ADDENDUM #04

DATE:	September 29, 2023	PROJECT NO.:	Project # 20229080 CRSA Project # 21-031
TO:	Gramoll Construction 155 S. 750 W. North Salt Lake, UT 84054	PROJECT:	Rio Grande Depot Seismic 300 S. Rio Grande St. SLC, UT 84101

This Addendum forms a part of the Contract Documents and modifies the original Bid Documents dated October 3, 2022 as noted below. Acknowledge receipt of this Addendum in the space provided on the Bid Form. Failure to do so may subject the Bidder to disqualification.

2023-09-29 11:29 AM
C:\Users\jstaf\OneDrive\Documents\RioGrande\2022\20229080\20229080-04.dwg
SARA STAFFANSON
11/11/2023

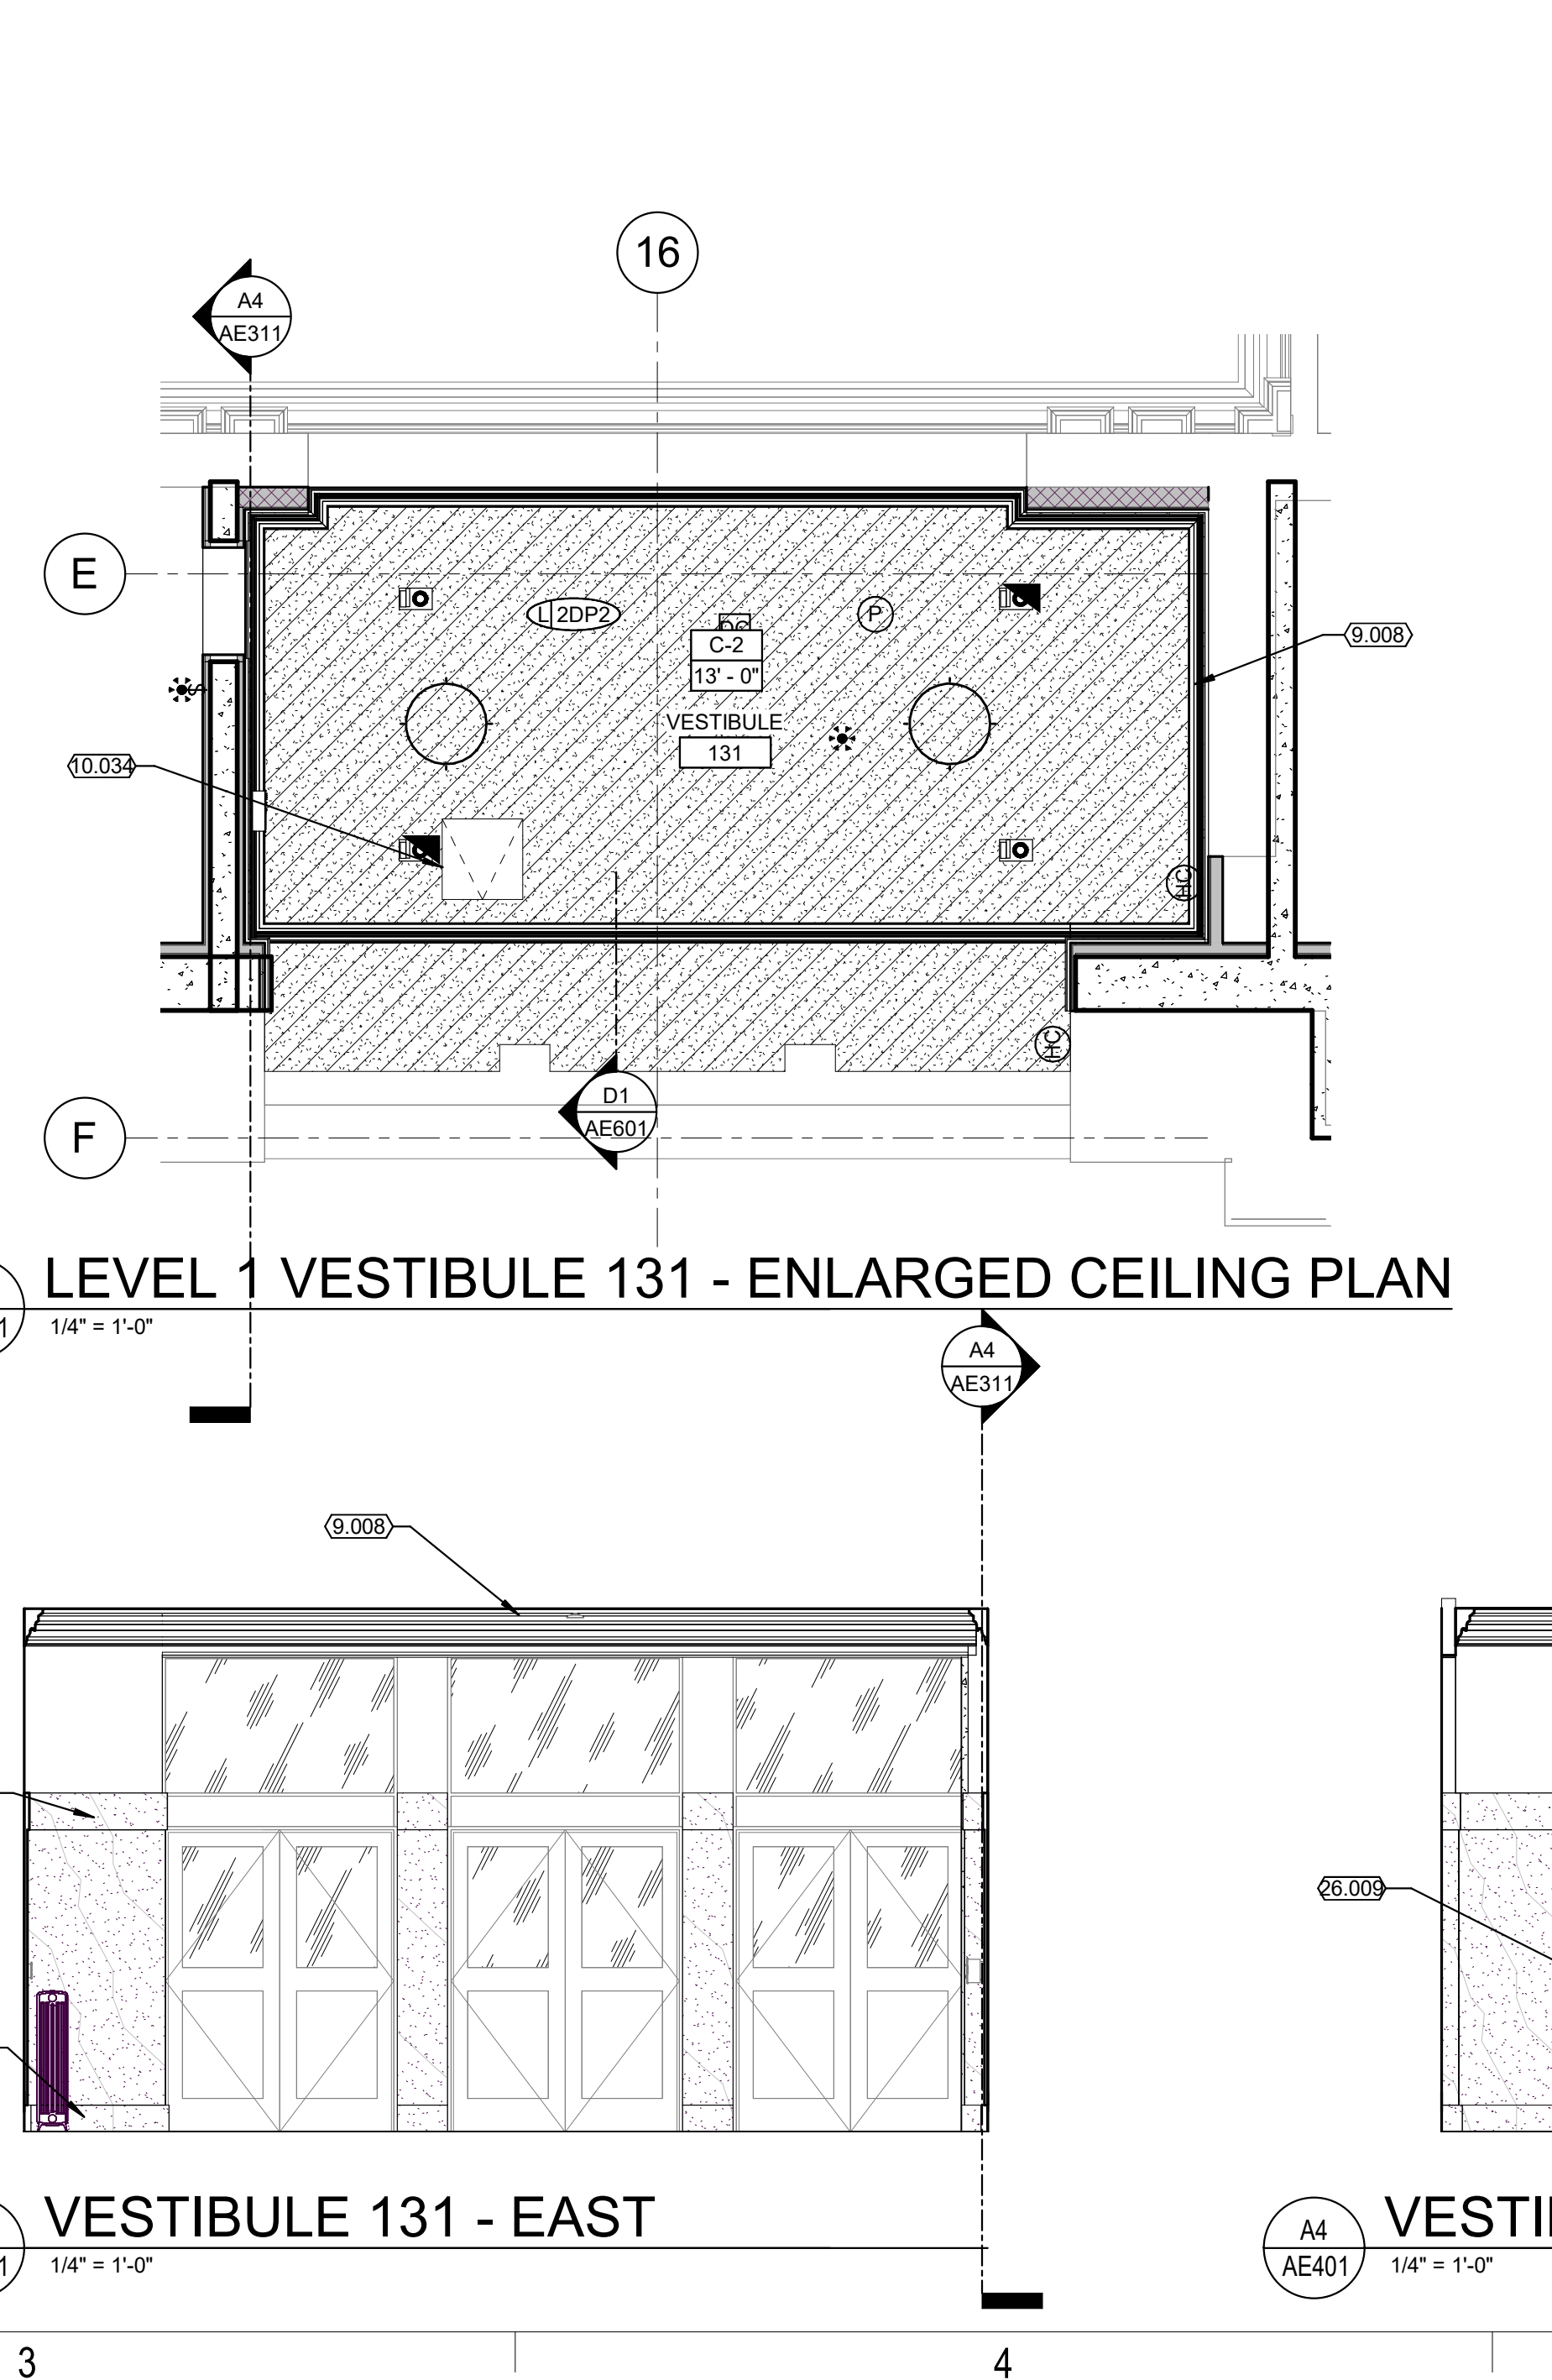
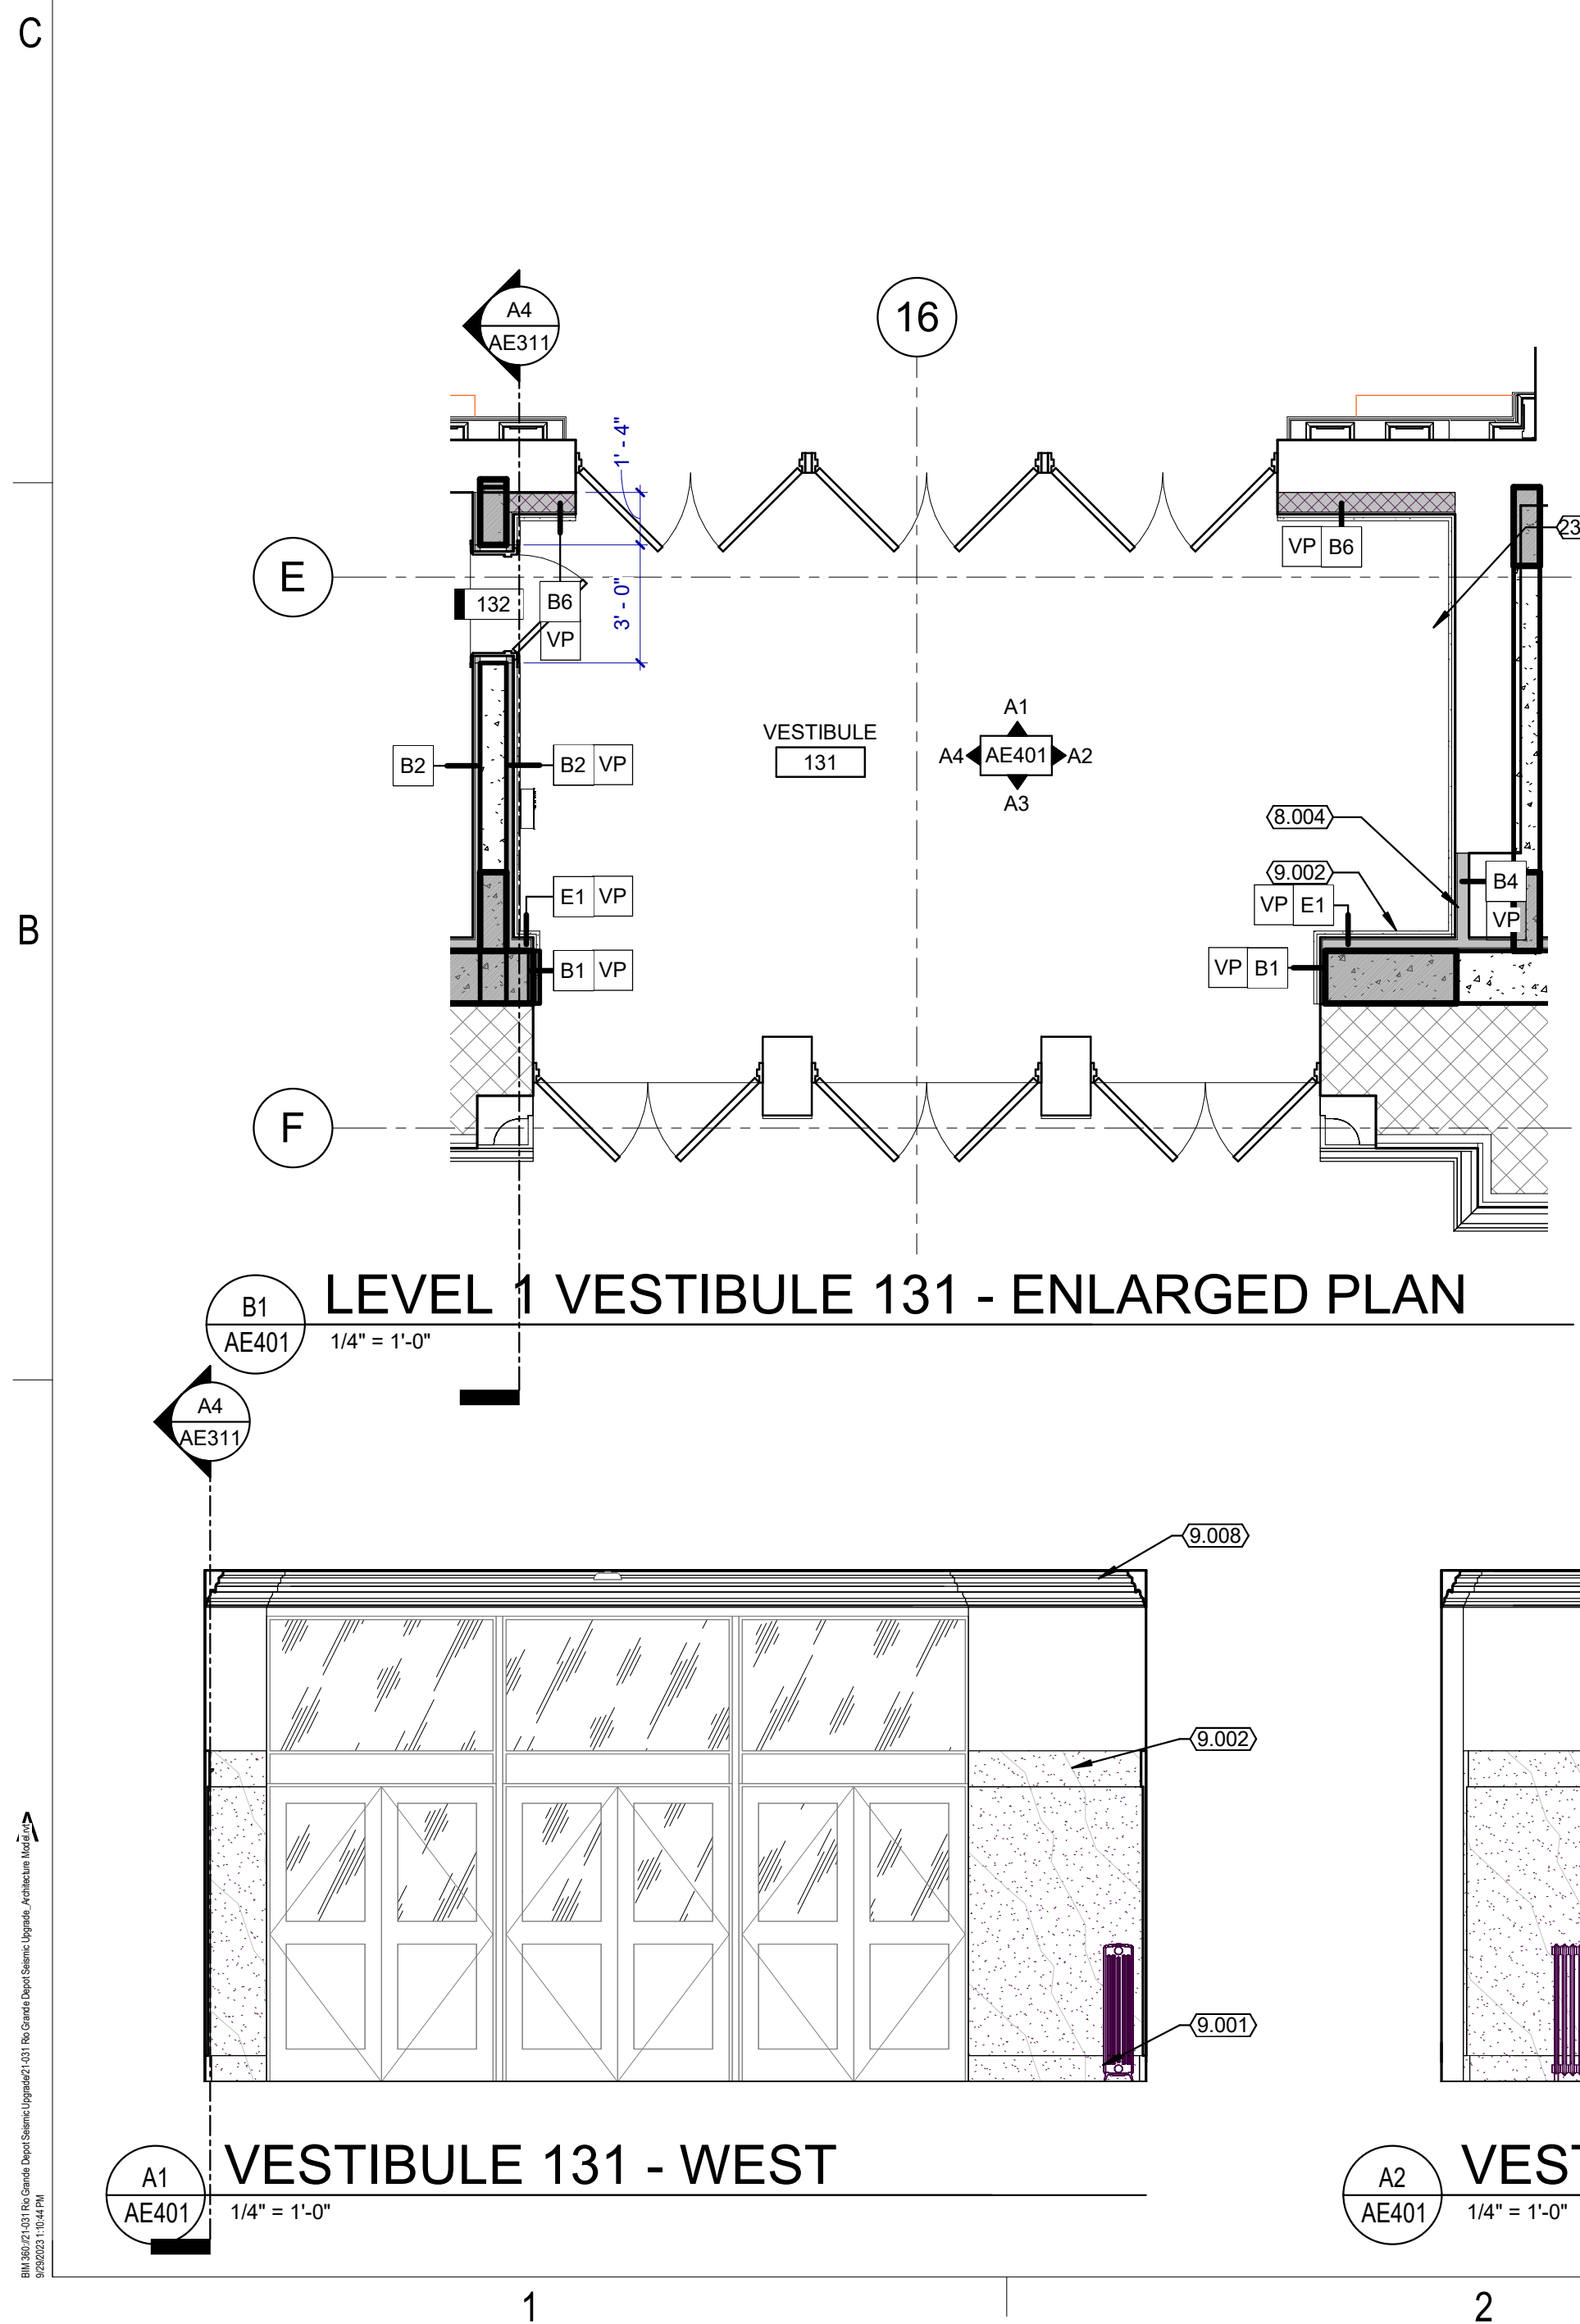
VI-2 AE400: Added VP wall type to plans.
